QUILEUTE - RIVER'S EDGE RESTAURANT - SITE PLAN 1

QUILEUTE NATION
RIVER'S EDGE RESTAURANT
41 MAIN ST
LA PUSH, WA 98350

A-2.3

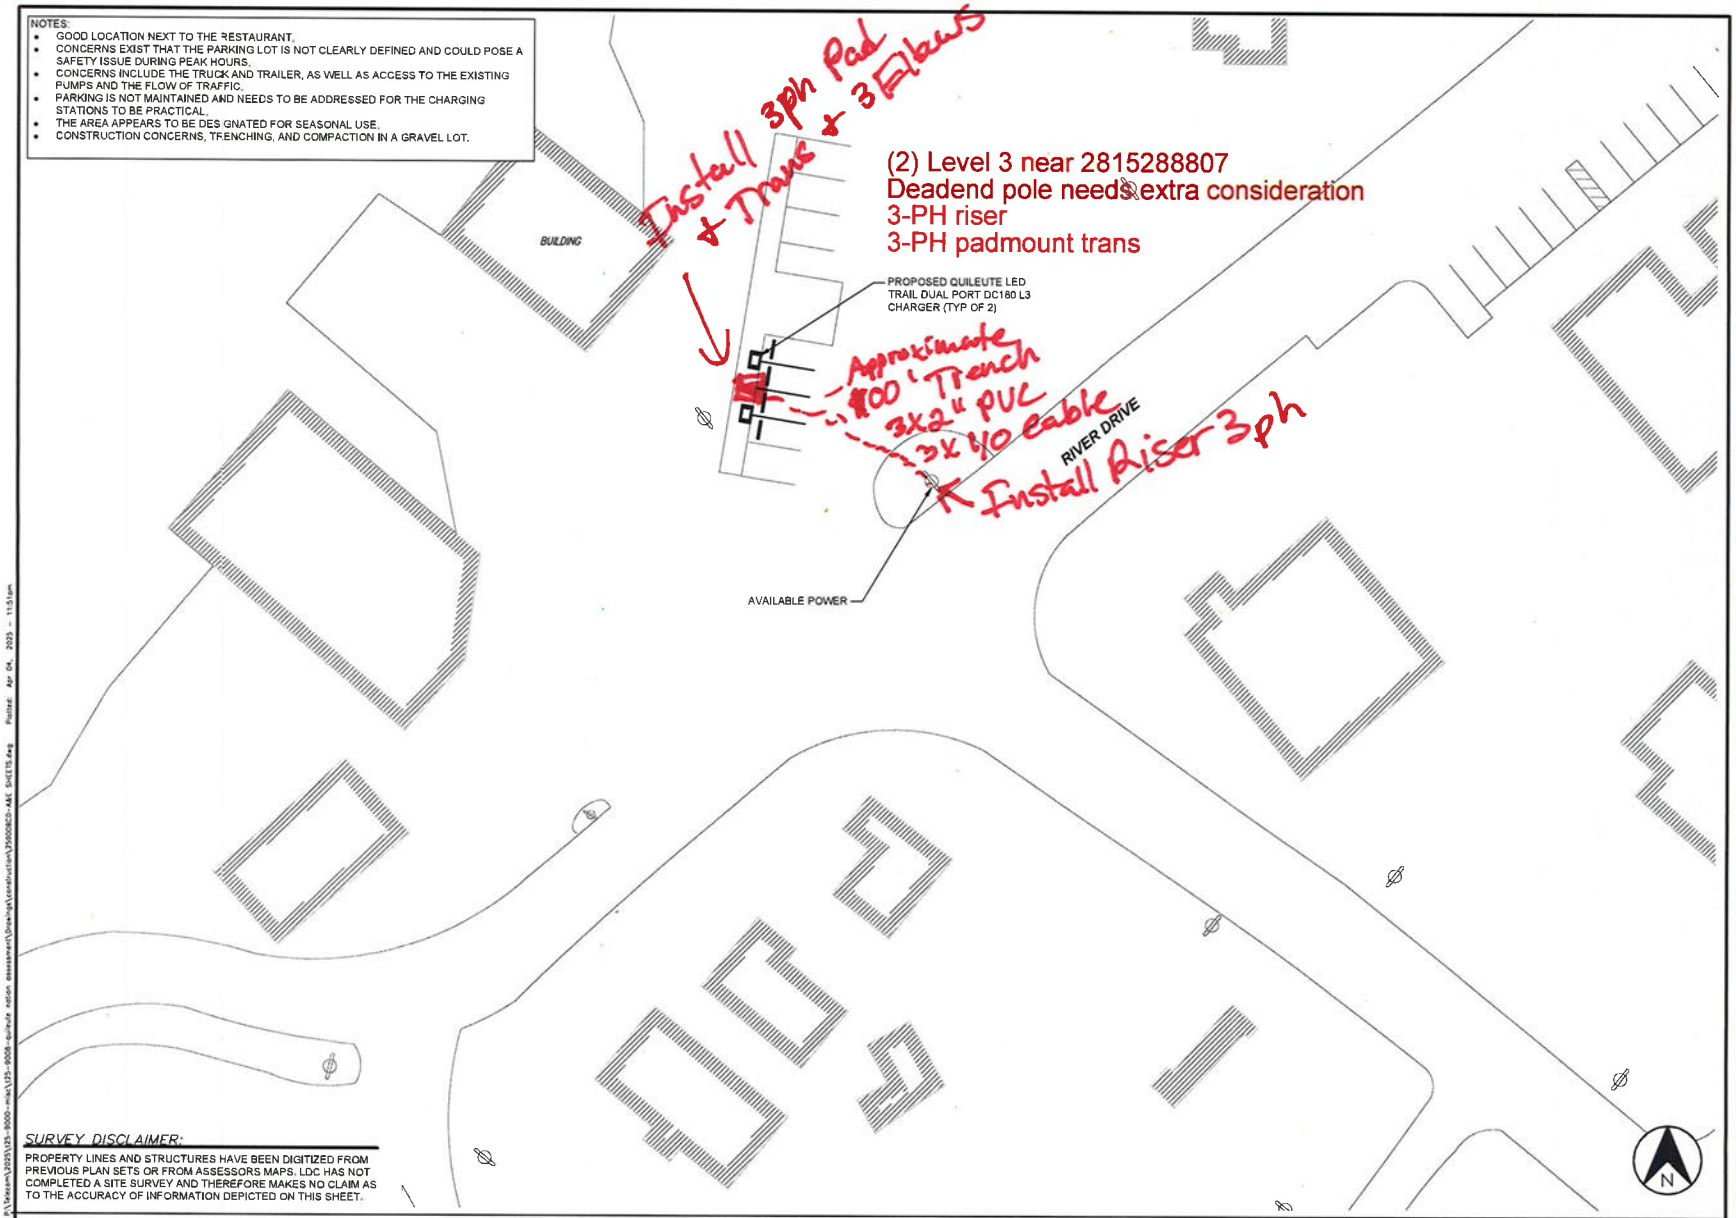
NOTES:
- GOOD LOCATION NEXT TO THE RESTAURANT.
- CONCERNS EXIST THAT THE PARKING LOT IS NOT CLEARLY DEFINED AND COULD POSE A SAFETY ISSUE DURING PEAK HOURS.
- CONCERNS INCLUDE THE TRUCK AND TRAILER, AS WELL AS ACCESS TO THE EXISTING PUMPS AND THE FLOW OF TRAFFIC.
- PARKING IS NOT MAINTAINED AND NEEDS TO BE ADDRESSED FOR THE CHARGING STATIONS TO BE PRACTICAL.
- THE AREA APPEARS TO BE DES GNATED FOR SEASONAL USE.
- CONSTRUCTION CONCERNS, TRENCHING, AND COMPACTION IN A GRAVEL LOT.
